# The Children's Hospital at Westmead Paediatric Services Building

## Architectural Design Statement - Addendum

State Significant Design Application No. SSD-10349252

Document Number: CHW-AR-DG-PSB-SSD081  
September 2021

Figure 4-1: Study of Folded Metal Panels

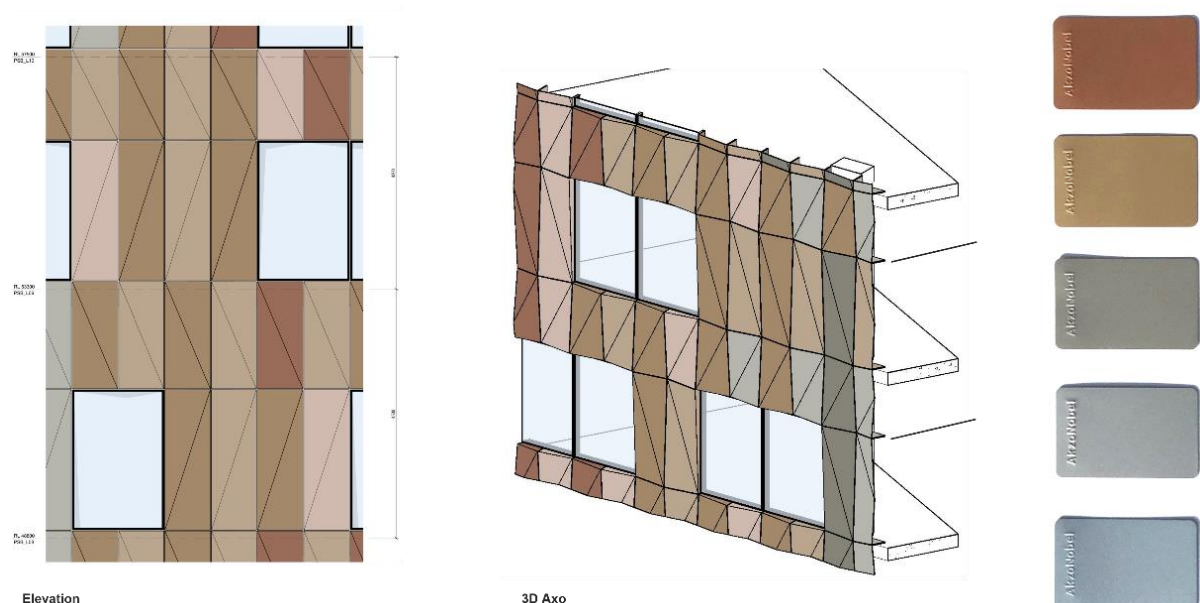
The façade will employ a series of shimmering metallic finishes, diagonally folded aluminium panels (inward and outward folding), to allow the light to bounce across the façade surfaces. This will create a dynamic and ever-changing materiality. At the end of each 'finger' are a series of winter gardens which will be clad in a series of glazed operable louvres to maximise distant views and access to fresh air.

Folded Panels will be arranged in an overall organised palette to create a macro folded/ ripple pattern across the façade. The folds will thus be visible both at close range and from a distance. The folded panels will create distinct shadow effects which will change throughout the day with the movement of the sun, reflecting changes in the sky, as water reflects changes in the sky.

Figure 4-2: Indicative Materials and Colour Selections

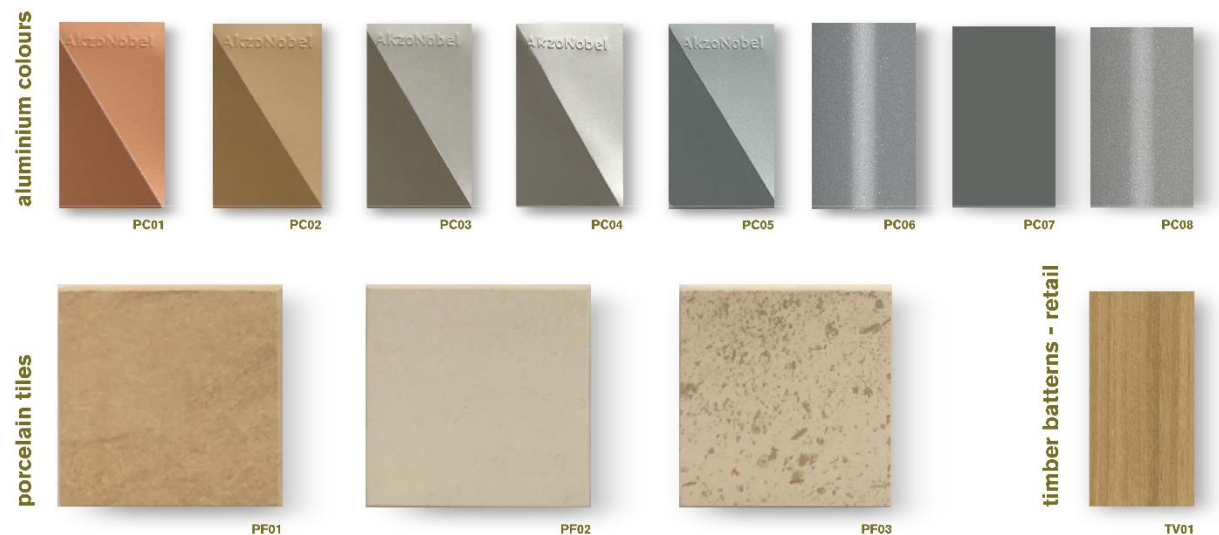
Riverbanks and edges are eroded by the movement of water, exposing linear stratification of the underlying geology. The podium façade design will be based on this concept. Windows in the podium will be set back with deeper reveals, alluding to openings in rock faces. The use of ceramic tile will be further enhanced through the use of colour variation and its arrangement into a macro pattern, representing the geological stratification.

Figure 4-4: Southeast Elevation (KR Lane)

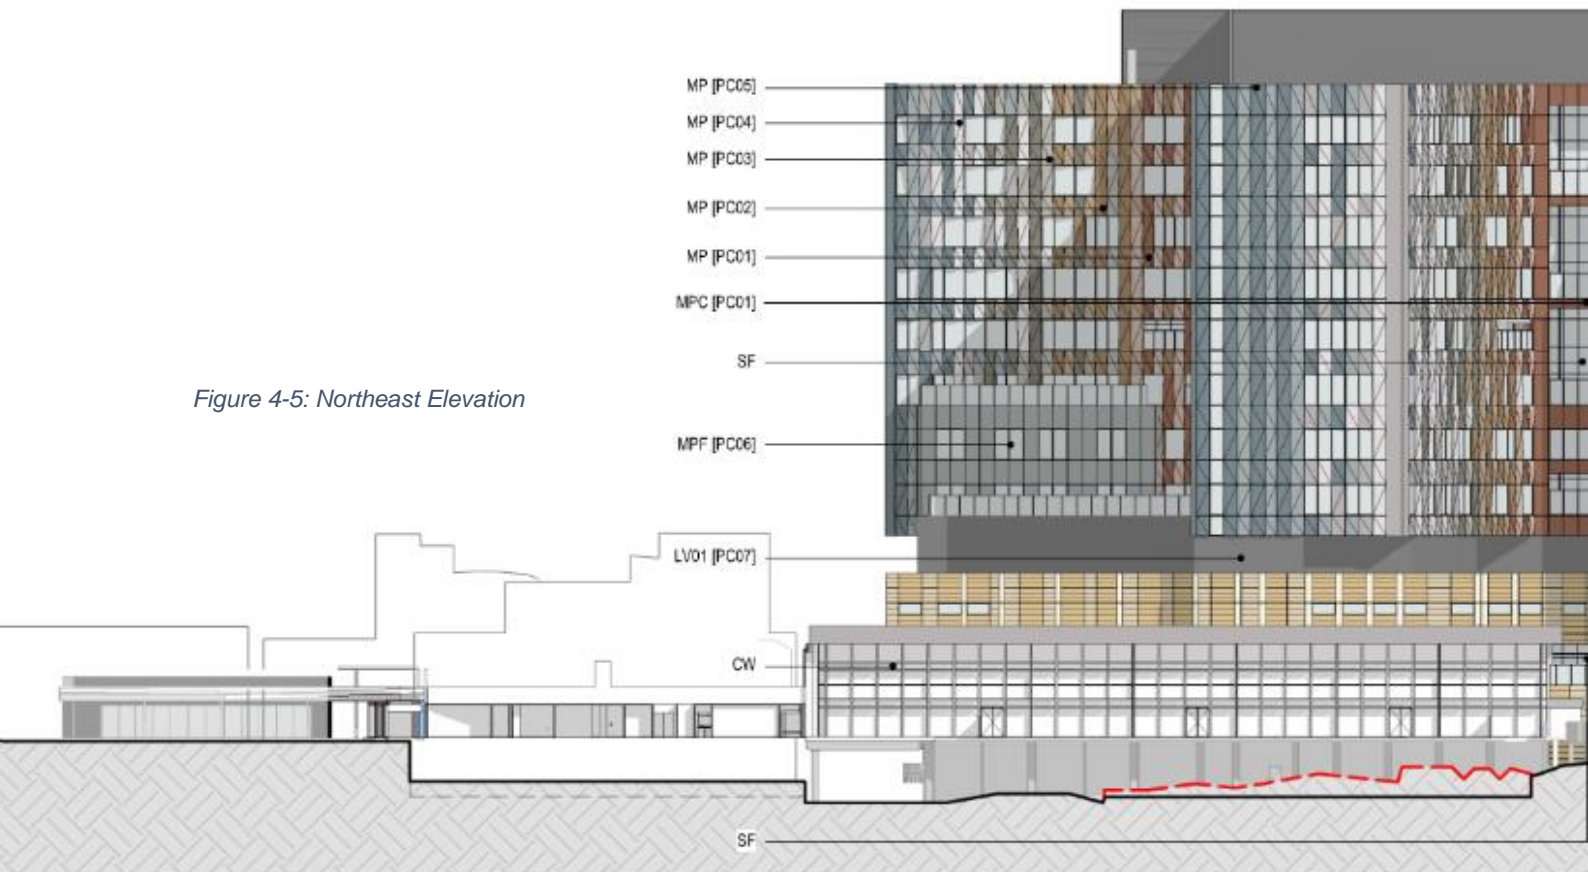
The overall number of façade types is minimised for clarity and construction efficiencies. Key façade types retain flexibility within the system to further articulate facades and adjust for internal planning changes. The amended façade types are listed below:
